**DEFENSE NUCLEAR FACILITIES
SAFETY BOARD**

Staff Report

General Corrosion Allowance for 304L and 316L Stainless Steel in the Waste Treatment and Immobilization Plant

SUBJECT: Erosion and Corrosion Wear Allowances in Hanford WTP

Figure 1. Arrhenius plot of corrosion rates for stainless steel in 50 wt% NaOH solutions.

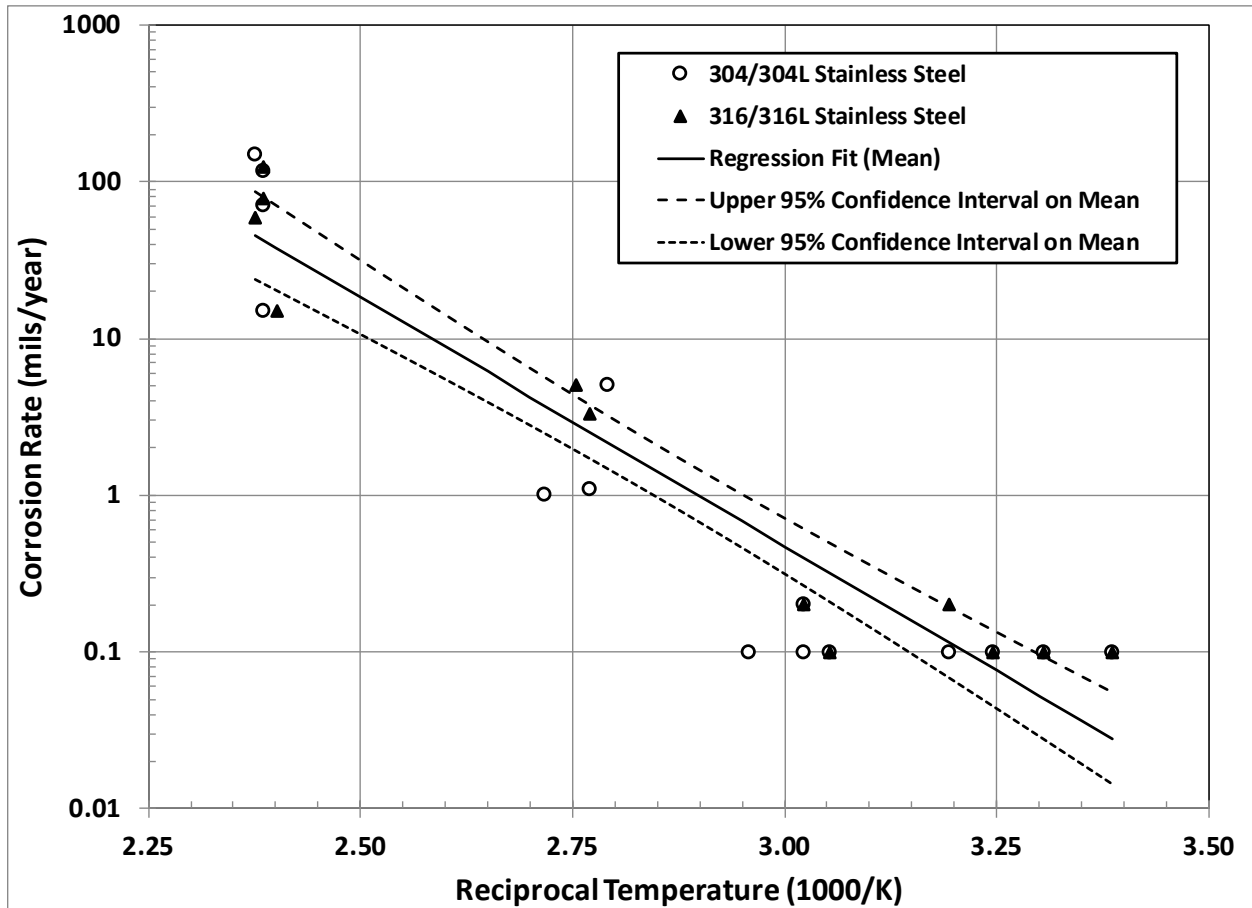
Determining Corrosion Rate as a Function of Temperature—Corrosion of stainless steel is a thermally activated process and therefore an Arrhenius equation is generally used to predict the exponential effect of temperature on corrosion rate [1]. Figure 1 below shows the general corrosion rate data from Table 1 plotted on a logarithmic scale as a function of reciprocal temperature. The solid line is a regression fit to an Arrhenius equation of the combined 304/304L and 316/316L stainless steel data:

where CR is corrosion rate, A is a normalized constant corrosion rate, E_a is the activation energy for corrosion, R is the gas constant, and T is absolute temperature. The correlation coefficient, $r = 0.943$ ($r^2 = 0.888$), implies a linear relationship between $\log(CR)$ and $1/T$ and supports the premise that the rate-controlling mechanism for corrosion remains constant over the temperature range of Figure 1.

Determining Activation Energy for Corrosion—The slope of the solid line in Figure 1 represents the activation energy for corrosion (divided by the gas constant, R), which can be compared with results reported in the literature. The activation energy in Figure 1 is 61 kilojoules (kJ)/mol, a relatively high value that reflects the large increase in measured corrosion rates for data tested at temperatures above approximately 185°F (less than 1000/Kelvin (K) = 2.79 in Figure 1). The standard deviation of the activation energy is 4.3 kJ/mol and the 95 percent confidence interval on the activation energy is 61 ± 8.9 kJ/mol, which corresponds to a 95 percent confidence that the activation energy range is between 52–70 kJ/mol. Reference 7 lists 316L stainless steel corrosion rate data reported in Reference 8 from tests in 0.1 M (0.4 wt%) NaOH concentrated alkaline (pH = 13) solutions at three different temperatures. A survey of corrosion data reported in Reference 9 shows an Arrhenius plot of the three 0.4 wt% NaOH solution data points tested at temperatures of 86–176°F as reported in References 7 and 8. The corrosion rates were very low (< 0.01 mpy), as would be expected for such a low NaOH concentrated alkaline solution at these temperatures. The activation energy for corrosion of 316L stainless steel calculated from this data is 50 kJ/mol [9].

Figure 2a. Corrosion rates for stainless steel in 50 wt% NaOH solutions up to the boiling point.

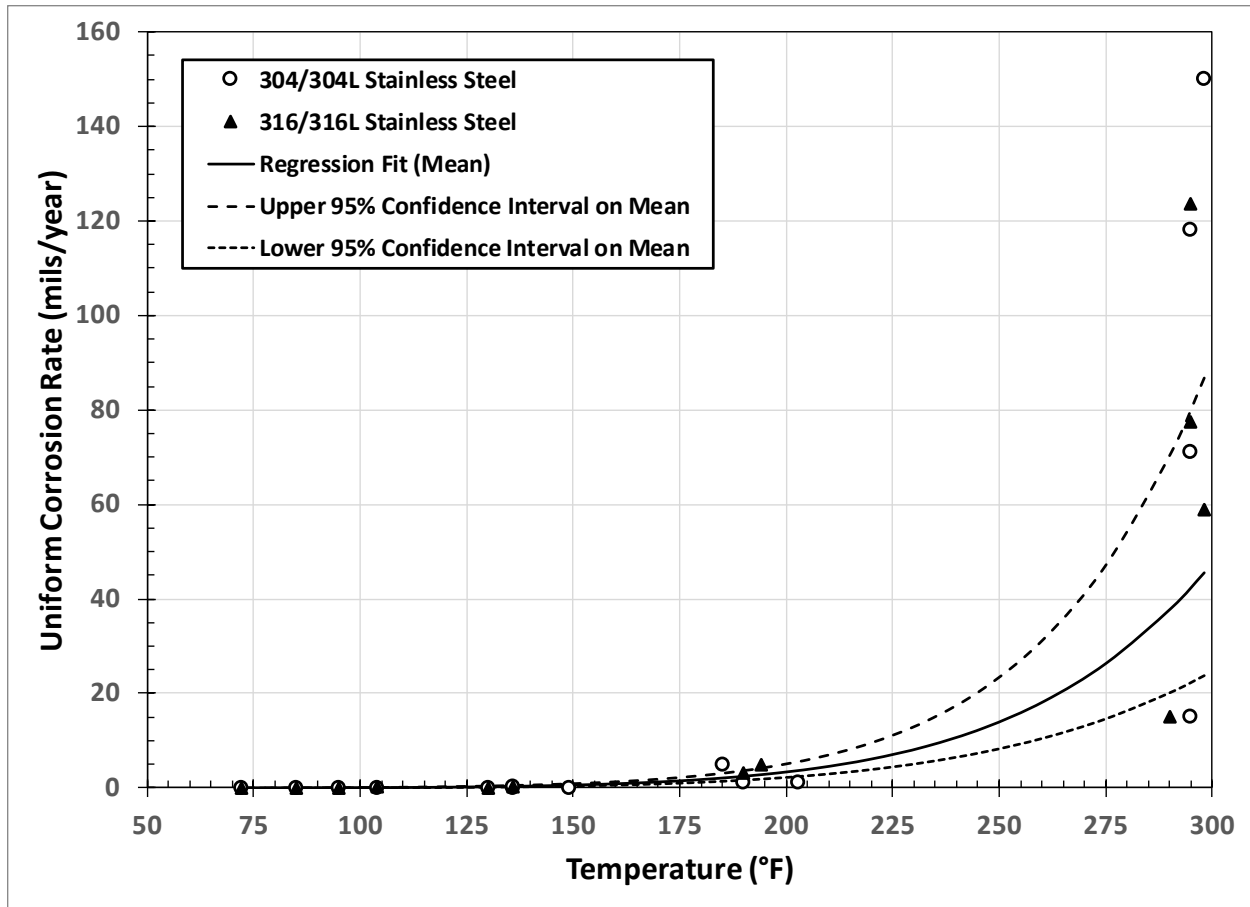
Plotting Mean Corrosion Rate as a Function of Temperature—Figures 2a and 2b below show the corrosion rate data from Figure 1 plotted as a linear function of temperature. Figure 2a shows all data at temperatures up to the boiling point of 50 wt% NaOH solution (~295°F), while Figure 2b shows the corrosion rate data only in the range of WTP allowable operating temperatures (< 200°F) for 316L stainless steel. The solid line in Figures 2a and 2b is the regression fit to the Arrhenius equation from Figure 1, which shows how the mean (expected) corrosion rate increases with temperature. The dashed lines show the upper and lower 95 percent confidence interval representing the highest and lowest mean values of corrosion rate at each value of temperature.

There is a relatively large amount of scatter in the corrosion rate data of Figure 2a measured at the boiling point and a relatively large variation of 1–5 mpy in the corrosion rate data of Figure 2b measured at 185–194°F. This is typical of the natural variability in experimental data that increases exponentially with temperature. The scatter is shown to be more uniform over the entire temperature range when the data is presented on a semi-log scale in an Arrhenius plot as shown in Figure 1 above. Because the regression fit is derived by minimizing the sum of the squares of the errors or scatter in the data, the solid line is the statistical best fit to the data. Approximately half of the data points lie above the regression fit (solid line) and approximately half lie below the solid line in Figures 1 and 2. The dotted line in Figure 2b shows WTP project's general corrosion allowance of 0.6 mpy.

Figure 2b. Corrosion rates for stainless steel in 50 wt% NaOH solutions at WTP operating temperatures.

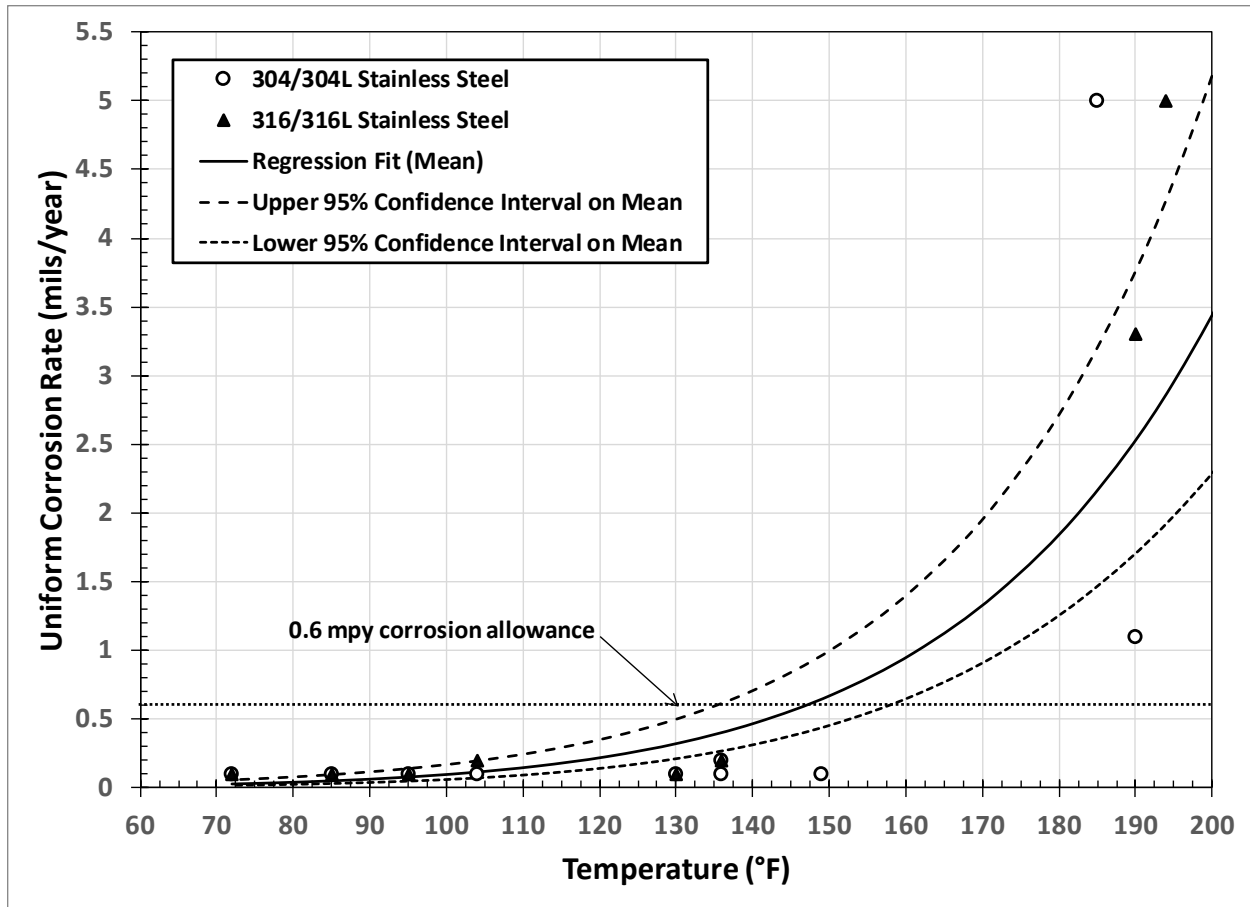
Figure 2b shows that all four of the corrosion rate data points from 185–194°F exceed WTP project’s general corrosion allowance of 0.6 mpy. Although the sole data point (149°F) from 137–184°F is well below the regression fit solid line, this data point is inconsistent with the corrosion rate data from 130–136°F and is essentially the same rate measured at 72–95°F. The corrosion rate is expected to increase exponentially with temperature as most of the other data in Figure 2 shows. The regression fit (solid line) in Figure 2b predicts the mean corrosion rate exceeds WTP project’s general corrosion allowance of 0.6 mpy (dotted line) at temperatures above ~147°F. The mean corrosion rate is predicted to be ~3 mpy in a 50 wt% NaOH solution at 194°F based on a regression fit to an Arrhenius equation of all the data measured from 72–298°F. The lower 95 percent confidence interval (short dashed line) in Figure 2b predicts with 95 percent confidence that the mean corrosion rate exceeds 0.6 mpy at temperatures above ~158°F. This is significant because the solid line is the predicted mean corrosion rate for 304L/316L stainless steel whereas the dotted line is WTP project’s bounding corrosion rate of 0.6 mpy for 304L stainless steel at temperatures up to 150°F and for 316L stainless steel at temperatures up to 200°F. The mean corrosion rate is predicted with 95 percent confidence to be at least ~2 mpy in a 50 wt% NaOH solution at 194°F based on a regression fit to an Arrhenius equation of all the data measured from 72–298°F.

This increase in stainless steel corrosion rate with increasing NaOH concentration is consistent with 304 stainless steel potentiodynamic anodic polarization data from the literature showing increasing current density and shifting of corrosion potential in the active direction with increasing NaOH concentration from 10⁻³ M (0.004 wt%) to 2.5 M (10 wt%) [11]. The regression fit of all the data measured from 72–298°F in 50 wt% NaOH solutions shown in Figures 1 and 2 predicts a mean general corrosion rate of 2.5 mpy with a lower 95 percent confidence interval of 1.7 mpy for 304/304L or 316/316L stainless steel at 190°F. This is well above the WTP project’s general corrosion allowance of 0.6 mpy. The four general corrosion rate data points at 185–194°F in 50 wt% NaOH solutions vary from 1–5 mpy in Figure 2b,

consistent with the regression fit prediction of the mean general corrosion rate of 2.5 mpy at 190°F.
